SERVICE No. 1020 BULLETIN

DATE: July 10, 1998

Inspection of the ARTEX 110-4 ELT and
ELT Attachment Bracket

**ELT Battery Pack
(Severe Damage from Battery Venting)
REPLACE UNIT**

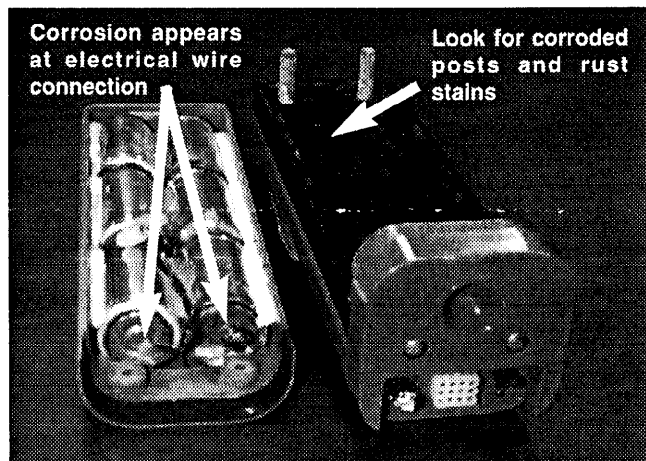
3. If the ELT battery pack does not pass the criteria as set forth in the ARTEX publication, the ELT battery pack must be replaced with a new ELT Battery Pack, Piper Part Number 758-696. *(See the data tag and corrosion photographs on page 3.)*
